ICC 2021 Code Changes

This document created by the Florida Department of Business and Professional Regulation -
850-487-1824

TAC: Accessibility

Total Mods for **Accessibility** in **Pending Review**: 49

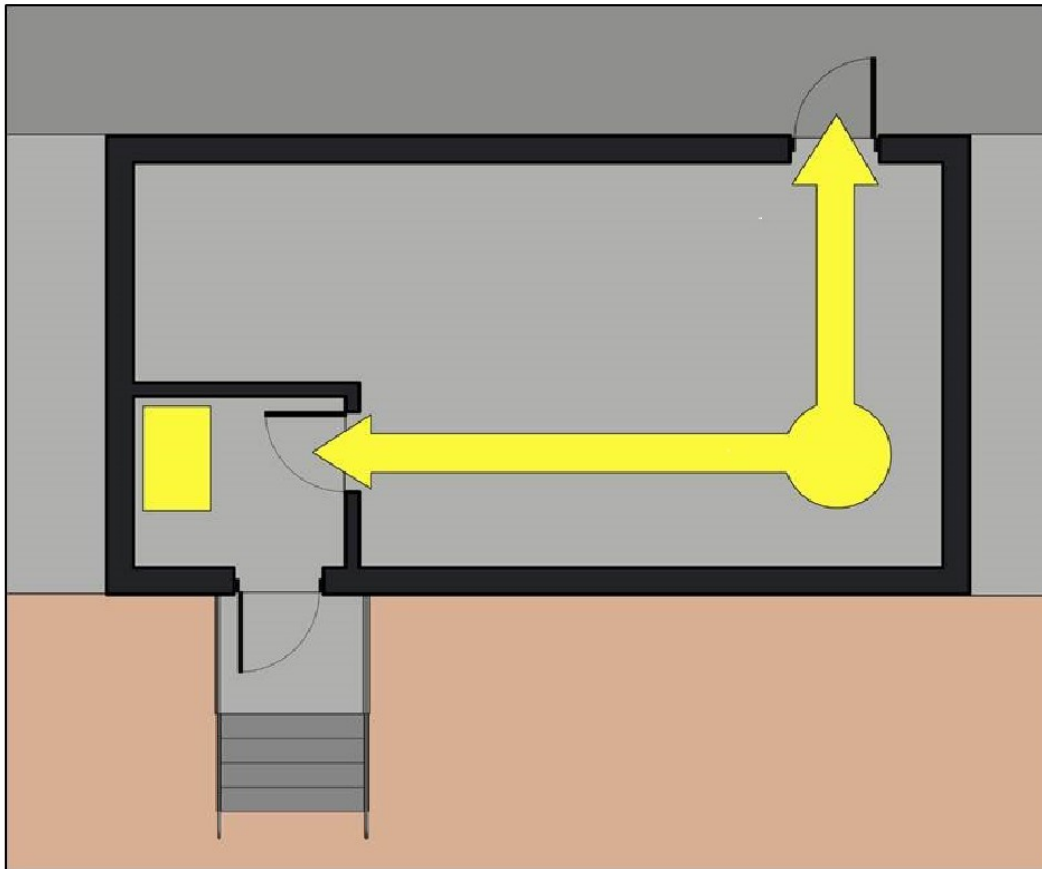
Commenter's Reason: The committee said that an interior area of refuge should be at a discoverable location. IBC Section 1009.9 and 1111.3 Item 3 require areas of refuge to be signed on the outside of the door leading to that area. That makes the area of refuge 'discoverable' by the occupants. The fire and safety plans in IFC 404.2.1 Item 4 and 404.2.2 Item 4.4.1 make sure the fire department knows where these areas are located.

Currently the text does not address an area of refuge in a single story building at the second exit. It only addresses areas of refuge on upper floors. The proposed text fixes that technical glitch.

The image below represents what this proposed code change is attempting to allow, an interior area of refuge with direct access to the exterior of the building.

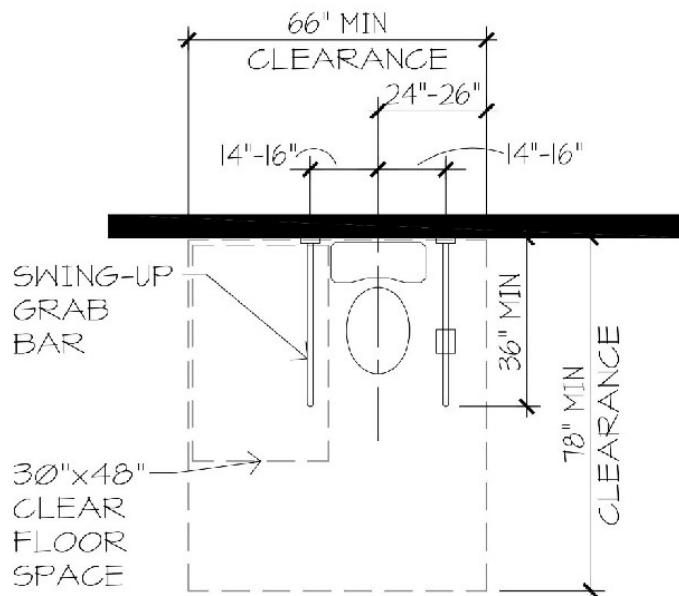
Reason: This is a part of a series of proposals for both scoping and technical criteria to allow for assisted toileting and bathing in some types of care facilities. We are asking for this technical criteria to be added into the IBC at this time due to the timing for the next edition of the ICC A117.1 – probably not referenced until the 2024 or 2027 code cycle. The format follows the ICC A117.1 for water closets for clarity and easy comparison of requirements.

In our educated opinion, these technical criteria will provide equivalent facilitation to the accessible toilet requirement in ICC A117.1 and the 2010 ADA Standard. These requirements are for toilets used by older adults or persons with limited upper body strength in care settings and where care-givers assist residents. It provides additional space between the toilet and any obstructions, such as a lavatory, cabinet or wall. Additional space is provided in front of a toilet to allow for additional approach options. Clear floor space for an unassisted side transfer is provided as well, consistent with 2010 ADA and A117.1. The provisions allow the use of fold-down grab bars in lieu of wall-mounted grab bars.

ASSISTED BATHING
ROLL-IN SHOWER -
USING EXCEPTIONS
EXAMPLE 1

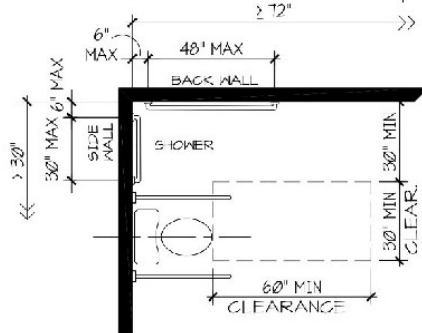
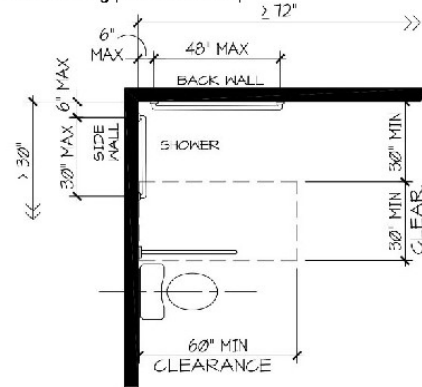
The key part of this change is to remove the requirement for permanently installed folding or fixed seats. These wall-mounted seats do not work well when residents are being assisted with showering. The wall mounted seats make it challenging for care-givers to access the back and one side of the resident they are bathing. Most often, if residents cannot stand for bathing, a portable, rolling chair is used and the folding seat stays folded up (but takes up space). This allows the care-giver greater access to all sides of the resident. In addition, the rolling chair is often easier to transfer to for older adults, than a wall mounted seat.

This proposal also recognizes alternate shower configurations that provide equal, if not better accessibility. For example, many nursing homes provide a "European" shower where two sides are open to the bathroom. This provides greater access for both resident with mobility issues as well as the care-giver. Water can be managed with shower curtains, either on a curtain track or an "L-shaped" curtain rod, however usually the entire room is designed to be a "wet room".
